Application Number: 22/03783/APP
Proposal: South East Aylesbury Link Road (Phase 2) improvement scheme including dual carriageway (for the Stoke Mandeville Relief Road and to provide connection with the South West Aylesbury Link Road), new roundabout, lighting columns, maintenance bays and access points, diverted public right of way, uncontrolled crossing, provision of two shared cycle/footways, noise bunds and barriers, relocated field accesses, grass verges, road restraint systems, mammal tunnel, flood compensation storage areas, woodland planting, landscaping, habitat creation, drainage ponds and swales, substation and associated infrastructure and earthworks
Location: Field To North Of Hall End Adjacent To Lower Road, Stoke Mandeville, Buckinghamshire.

Thank you for your request for consultation on the South East Aylesbury Link Road (SEALR) Phase 2. An initial Highways response was submitted on the 22nd December 2022 which commented on the Transport Assessment dated 10th November 2022. An additional Technical Note, dated 26th January 2023, has now been received, a Technical Note relating to Highway Design dated 20th February 2023 and updated plans which include General Arrange

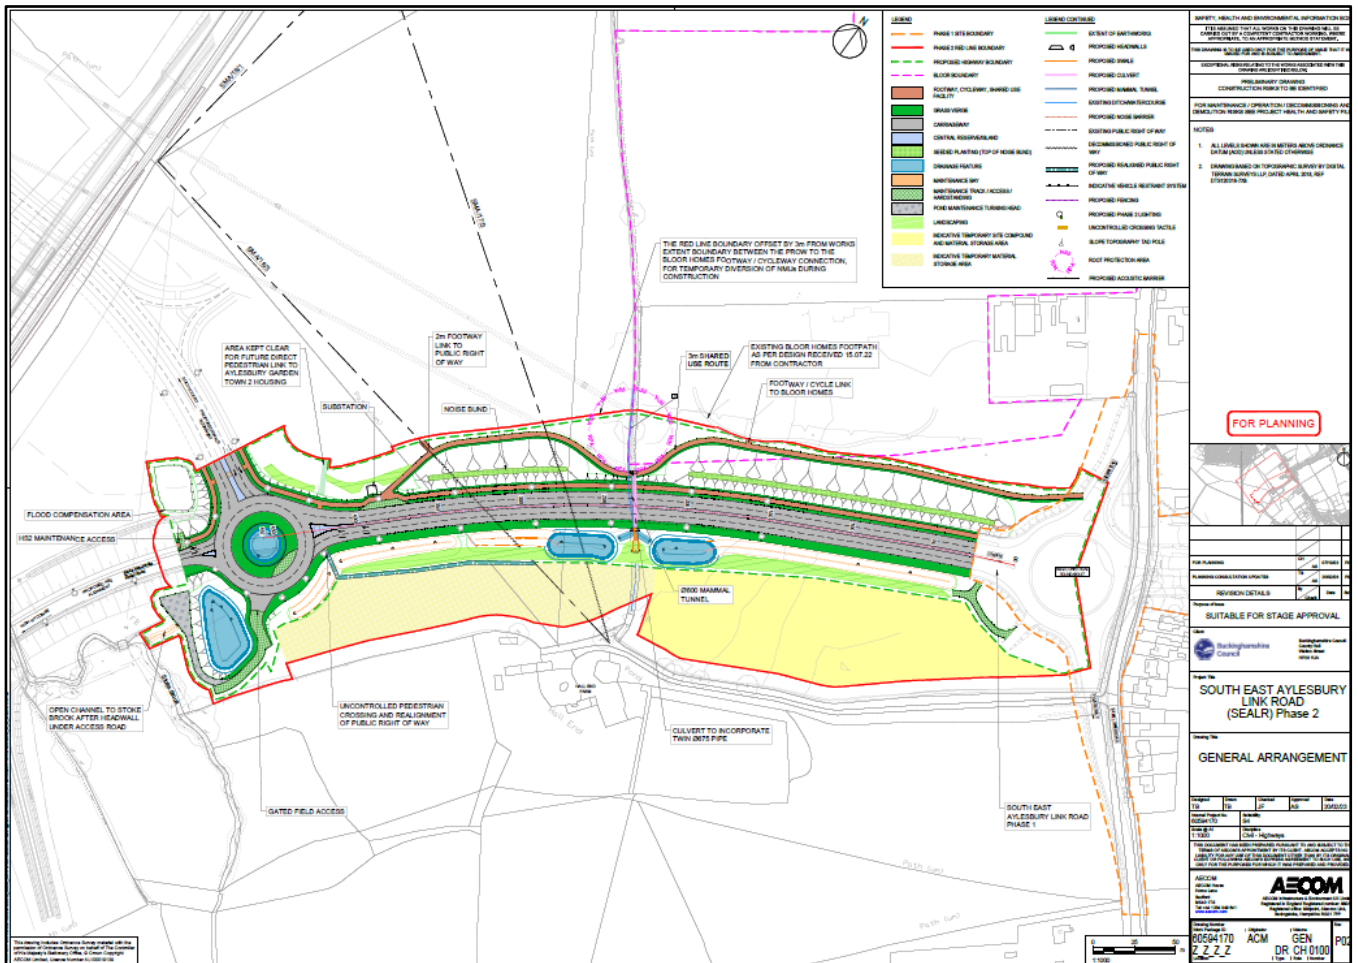
The February submission includes an updated General Arrangement plan, reproduced below. It shows that the northern footway /cycleway at the bottom of the embankment now bends round a tree protection zone broadly half way along the road.

The proposed amendment to the layout is considered acceptable.

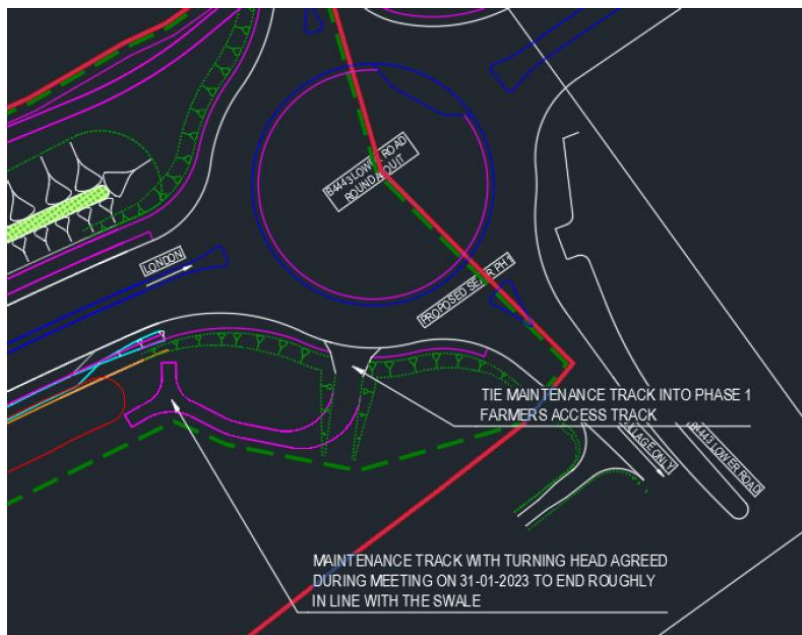
In the previous Highways Response BC also expressed a concern with regards to the location of the maintenance hardstanding located in the centre of the SMRR / SWALR / SEALR 2 Roundabout as it could create potential conflict and it was requested that the maintenance hardstanding was removed from the roundabout and repositioned in a more suitable location.

The Technical Note states that "*The maintenance hardstanding will be used infrequently and then only by the maintenance authority for grass cutting (or pond maintenance if required). It is expected that its use may only be needed once or twice a year. As such the location of the maintenance bay, as proposed, is considered to be suitable.*"

After consideration of the issues further including acknowledging the slower circulatory speeds and the frequency of use, it is considered that the hardstanding in the roundabout is acceptable.
